ADDENDUM NO. 2

PROJECT TITLE: GA Apron and Taxiway C

DATE: June 3, 2025

Coolidge Municipal Airport GA Apron and Taxiway C FAA AIP 3-04-0011-018-2025 (Design) FAA IIJA 3-04-0011-019-2025 (Design) Project No. AIP-01-2024 Addendum No. 2

191593014 DRAWING NAME 191593014NT02.dw C1.3

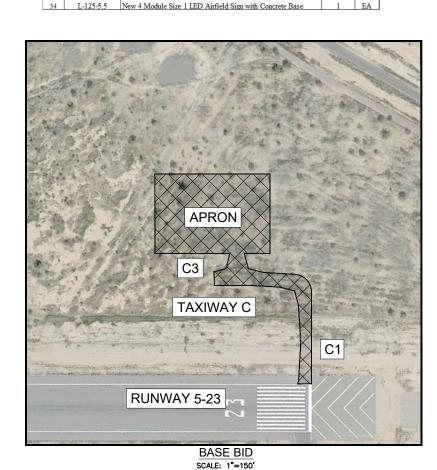
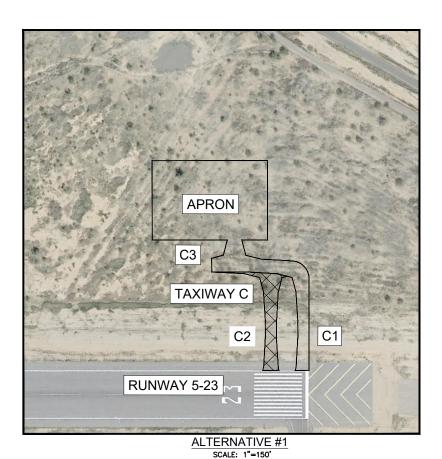
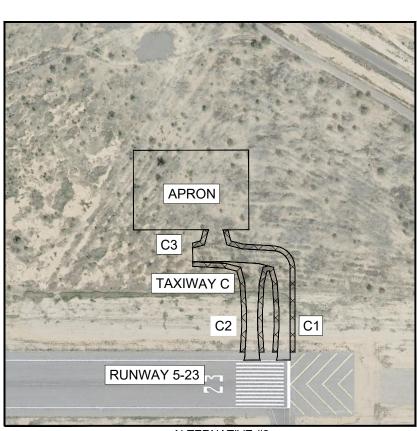
Sheet Number	Title Description	Narrative
C1.3	Summary of Quantities	Updated project quantities for item 11 in Alt 2

No.	Specification Number	Bid Item Description	Quantity	Unit
1	C-100	Contractor Quality Control	1	LS
2	C-102-5.1	Storm Water Pollution Prevention	1	LS
3	C-105	Mobilization/Demobilization (Maximum of 5%)	1	LS
4	SP-60.1	Airside Safety and Security / Traffic Control	1	LS
5	P-152-4.1	Unclassified Excavation	470	CY
6	P-152-4.2	Fill with Select Material	40	CY
7	P-152-5.1	Compacted Subgrade (10 In. Depth)	3,060	SY
8	MAG 702-4.1	Crushed Aggregate Base Course (6") (Not FAA AIP Eligible)	510	CY
9	MAG 710-5.1	A sphaft Concrete (4") (Not FAA A IP Eligible)	510	TONS
10	P-620.1	Reflective Vellow Taxiway Pavement Markings, Waterbome	1,740	SE
11	L-125-5.6	NEW 3" L-861T Base Can Extension, Including Hardware Installed (Not FA A AIP Eligibile)	48	EA
